SUBJECT: Coastside Design Review Recommendation
Cortez Avenue, Miramar
APN 048-032-070; County File No. PLN 2018-00397

At its meeting of April 11, 2019, the San Mateo County Coastside Design Review Committee (CDRC) considered your application for design review recommendation to allow construction of a new 1,732 sq. ft., two-story single-family residence, plus a 380 sq. ft. two-car attached garage, located on an existing 4,400 sq. ft. legal non-conforming parcel (legality confirmed via PLN2014-00116), as part of a hearing-level Coastal Development Permit (CDP) and a Non-Conforming Use Permit (UP). The Use Permit is required to allow development on a non-conforming parcel that proposes right and left side setbacks of 5 feet. and 7 feet., respectively, where 10 feet. is the minimum allowed for each side. No trees are proposed for removal. The Coastside Design Review Committee was unable to determine the findings for design review approval based on certain design deficiencies. In order to resolve these deficiencies in the project's design, a more thorough review of the "Standards for Design for One-Family and Two-Family Residential Development in the Midcoast" manual is required, with

FLOOR PLANS

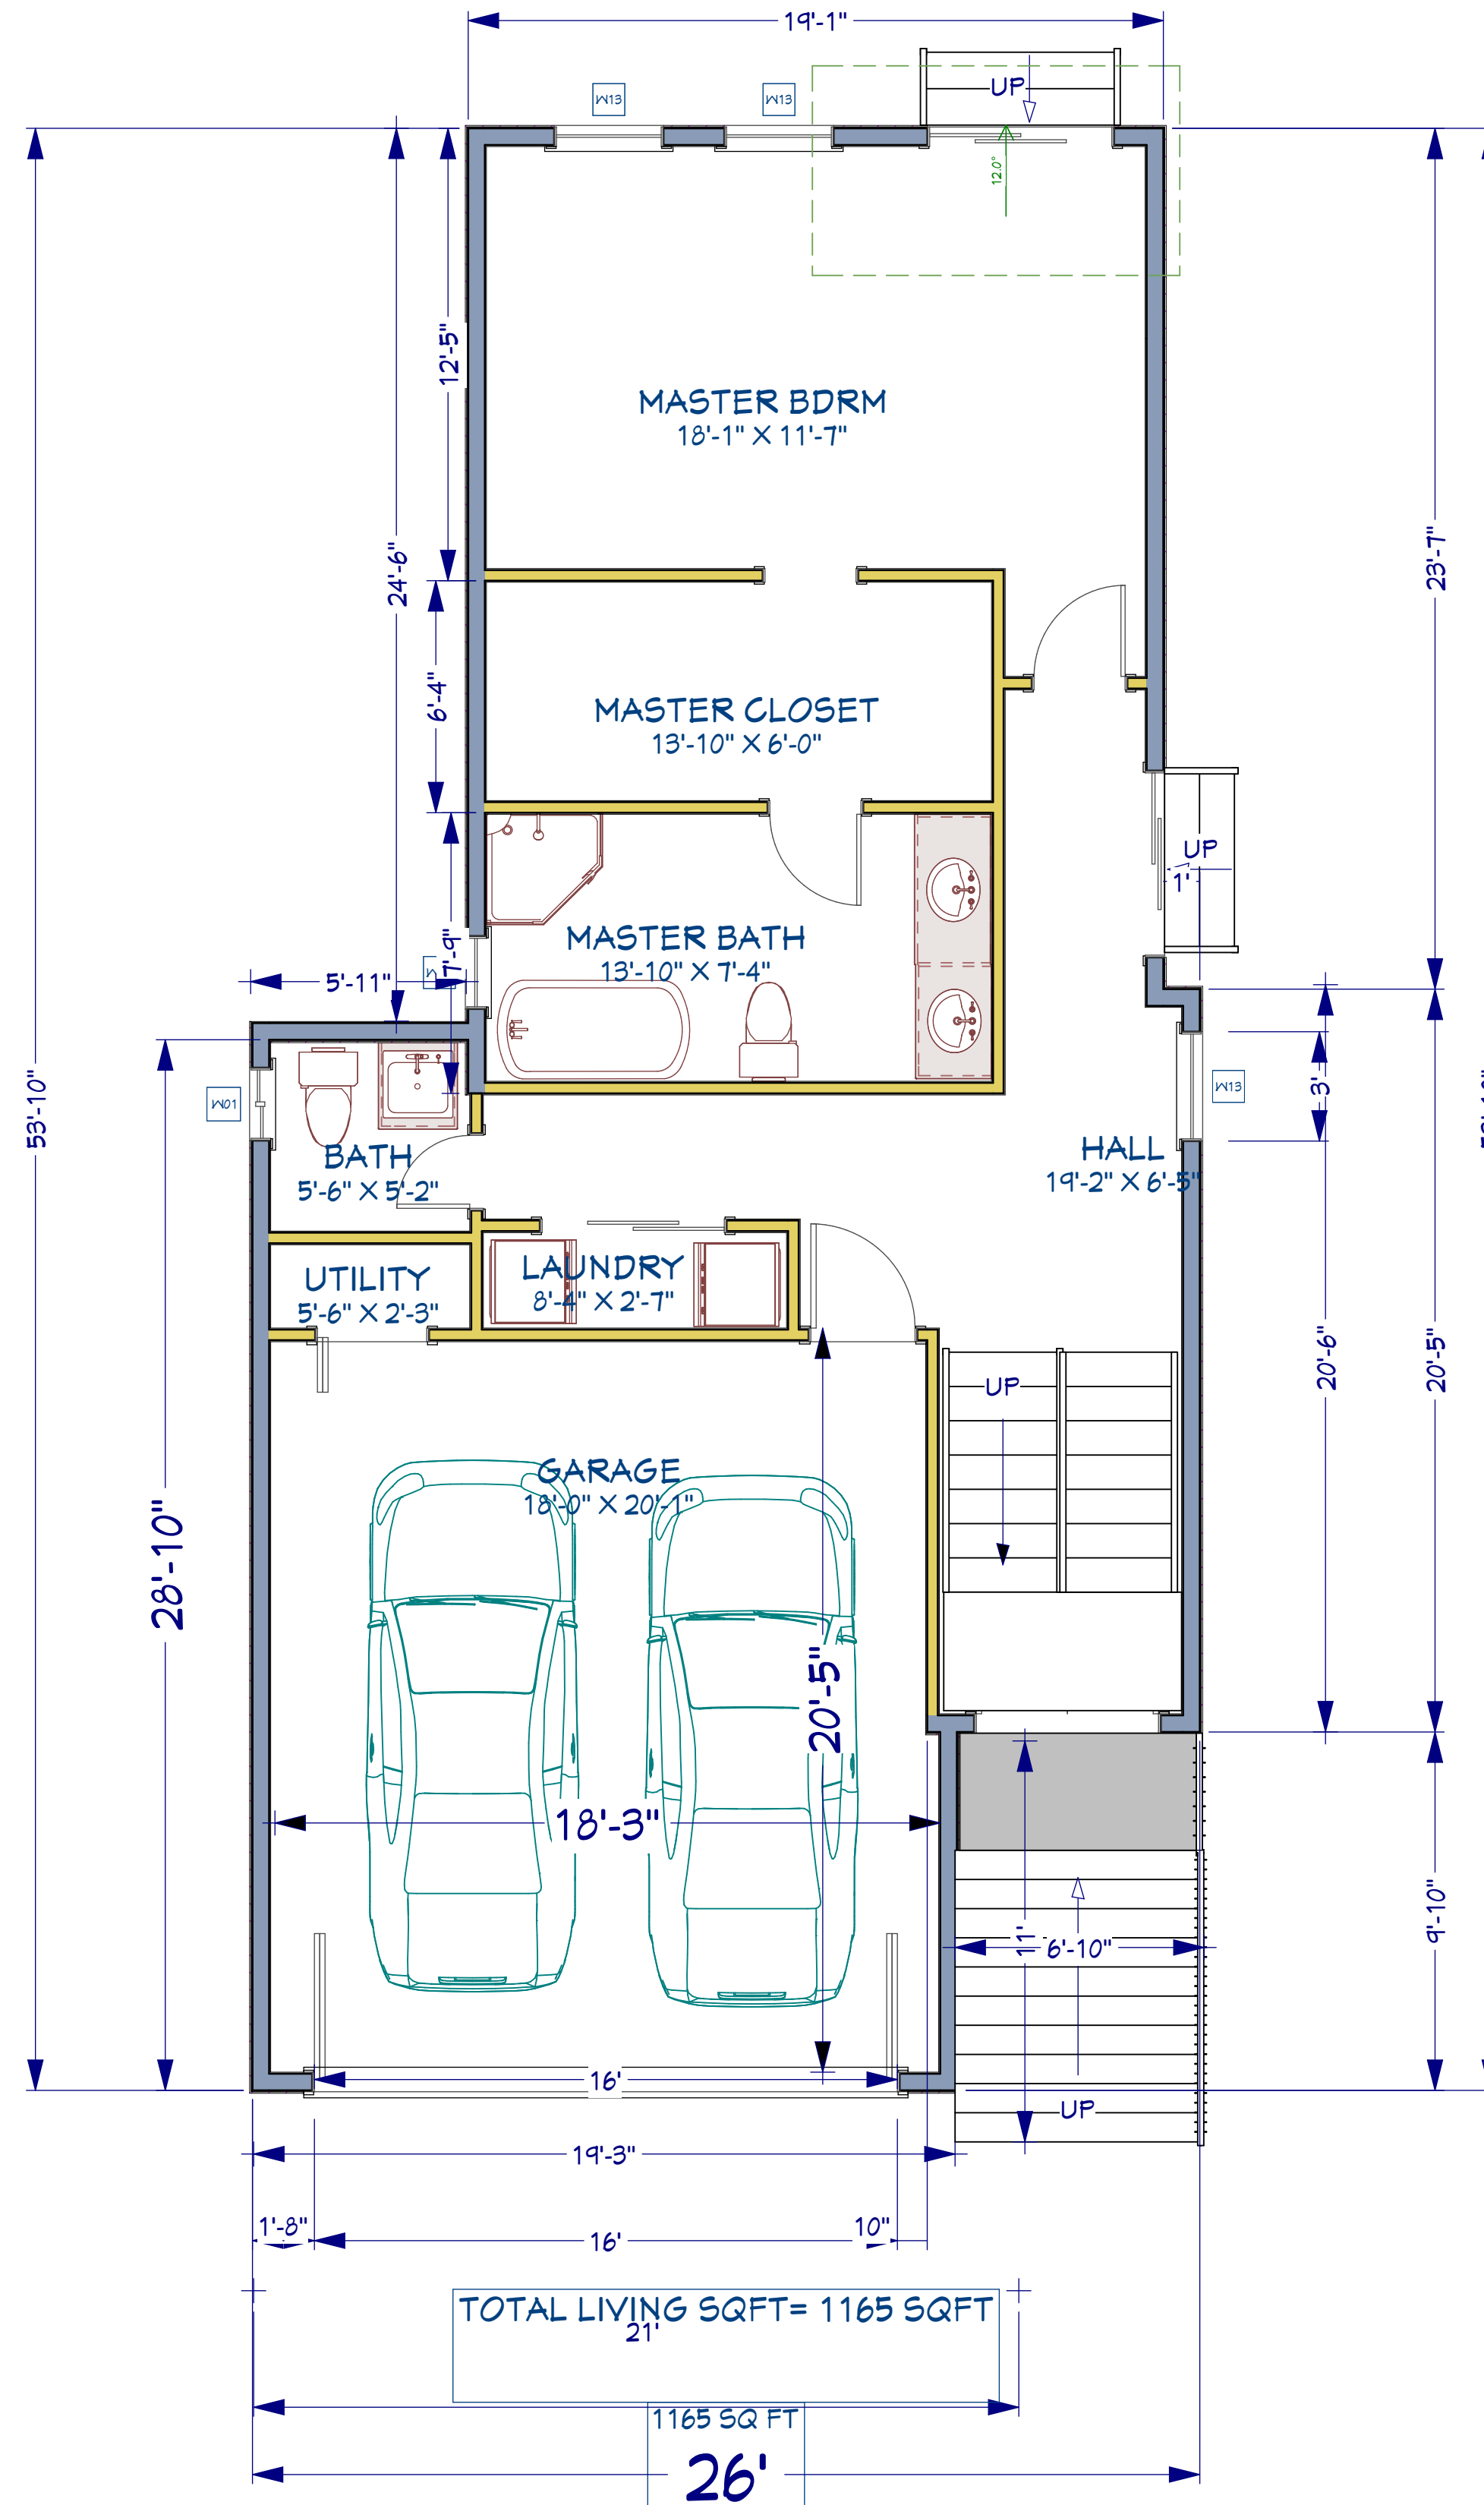
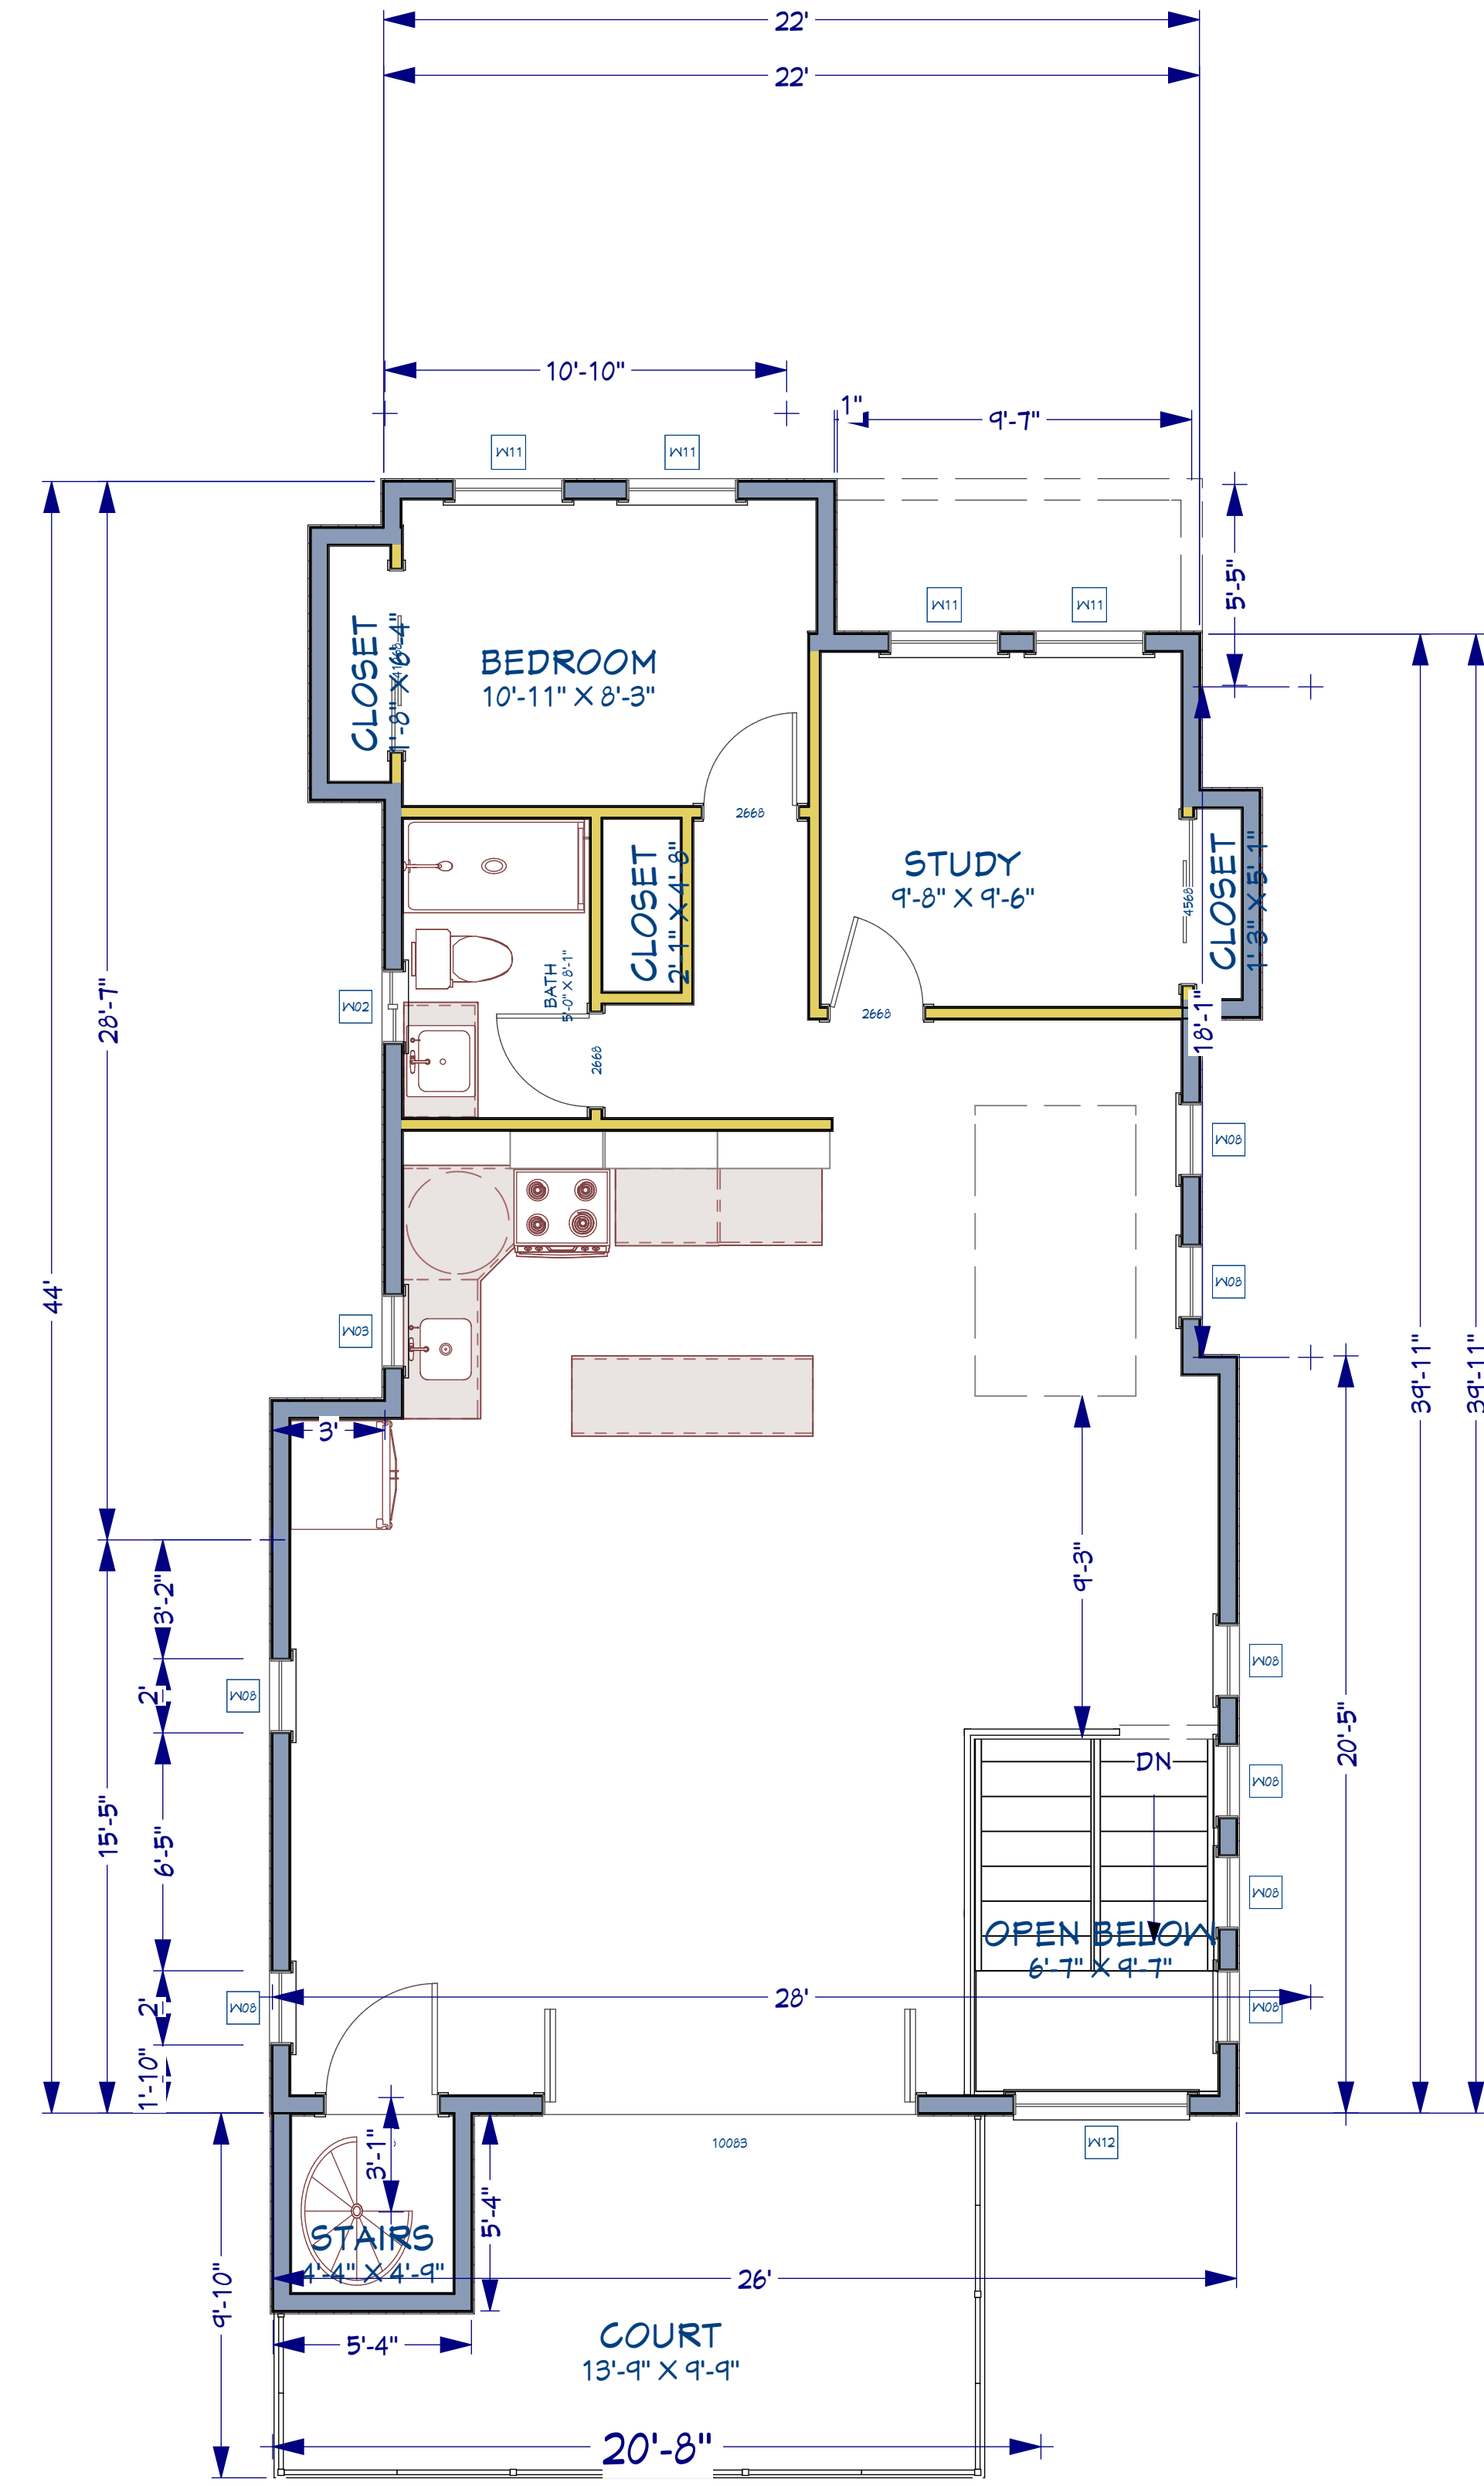
12. Garage parking does not provide minimum clear dimensions (18' wide by 19' long). Correct this to ensure it does not affect the exterior design in the permit drawings.

- Garage parking does not provide minimum clear dimensions (18' wide by 19' long). Correct this to ensure it does not affect the exterior design in the permit drawings.
Redesign: Garage now meeting the minimum clear dimension. Actually little bigger then what is required. 18x20.

Elevations

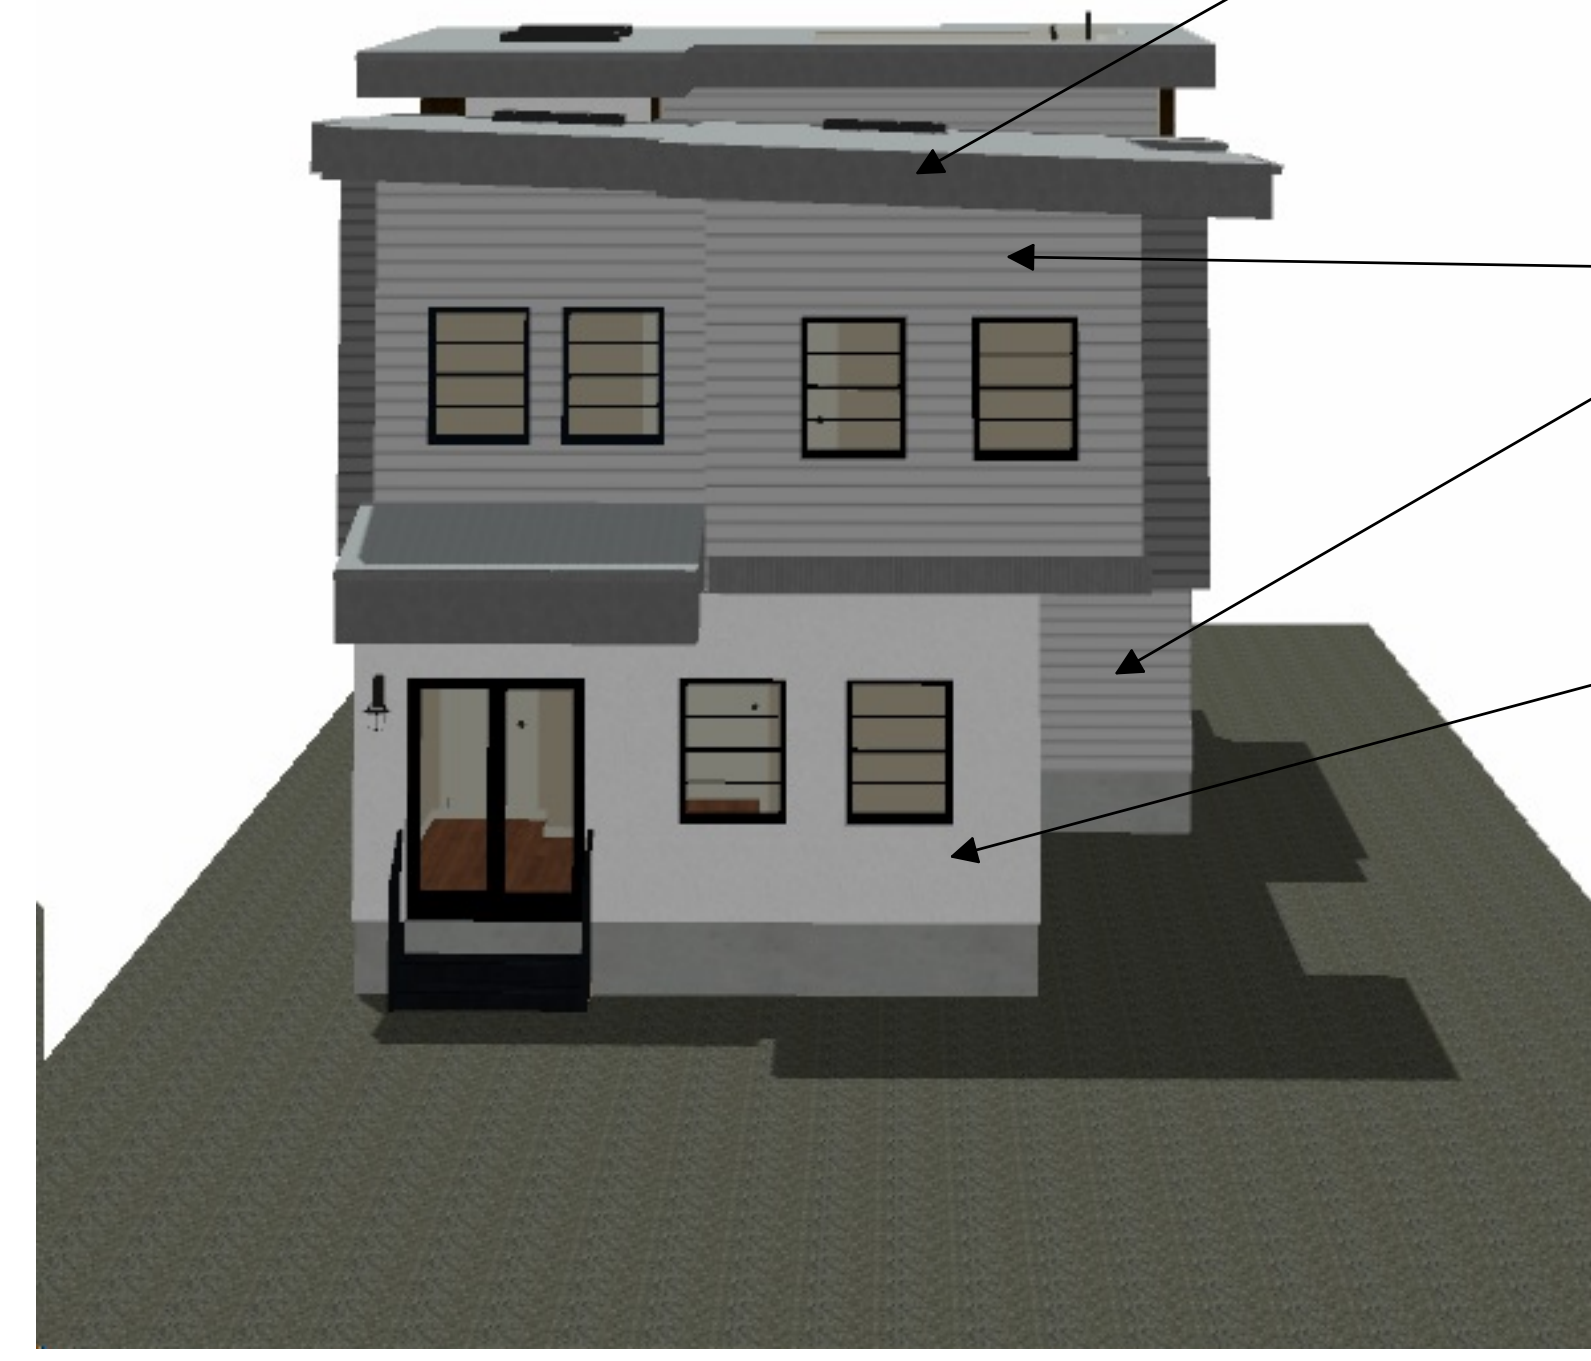
4. Revise the proportions of vertical windows on South and East side of entry stair to reduce the vertical expression at the front door for better overall proportions.

5. Eliminate mullions/muntins in windows. Simulated horizontal divided lite on picture windows would be acceptable to coordinate with single hung windows.

6. Use exterior colors closer in tonality, soften colors, no black trim, and roof.
7. Consider using cable rail and parapet wall sections on roof deck.
8. Reduce vertical wall sections, use of both glass and stucco should be lessened to modulate the roof form so that it does not have a single slab appearance.

- Coordinate window head/sill heights to be consistent.
Redesign: Exterior sills have been removed. Heights of all windows are now consistent.
- Revise the proportions of vertical windows on South and East side of entry stair to reduce the vertical expression at the front door for better overall proportions.
Redesign: Remove 2 window on the south side and made it one square window to reduce the verticalness. East Side windows length shorten from 10 ft to 6 ft.

- Eliminate mullions/muntins in windows. Simulated horizontal divided lite on picture windows would be acceptable to coordinate with single hung windows.
Redesign: Remove the Vertical mullions from windows. Add horizontal lite to shorten the verticalness of the windows.

- Use exterior colors closer in tonality, soften colors, no black trim, and roof.
Redesign: Remove black color completely. Soften color now chosen for the house and trim. Black roof has been replace with Dove Grey color.

- Reduce vertical wall sections, use of both glass and stucco should be lessened to modulate the roof form so that it does not have a single slab appearance.
Redesign: ~~Roof~~ Patio and front now completely redesigned. Use of Mahogany color cedar wood siding lessened the stucco front appearance. South side Tall vertical windows now replaced with square window with horizontal lite.

- Colors are now soften, removed black trim.
- Roof deck and Patio and stair case glass panel removed.
- Landscape completely redone
- Vertical windows are now shorten from 10ft to 6ft.

- Black stucco trim around windows removed.
- Use of cable rails on Patio and Front stairs.
- Verticalness of walls and windows are now removed.
- House now fully articulated.

- Use of Mahogany color wood and Vinyl siding has been introduce to soften stucco look.
- Reduce size of roof fascia board from 2ft to 18 inches.
- Removed vertical Mullions from windows.
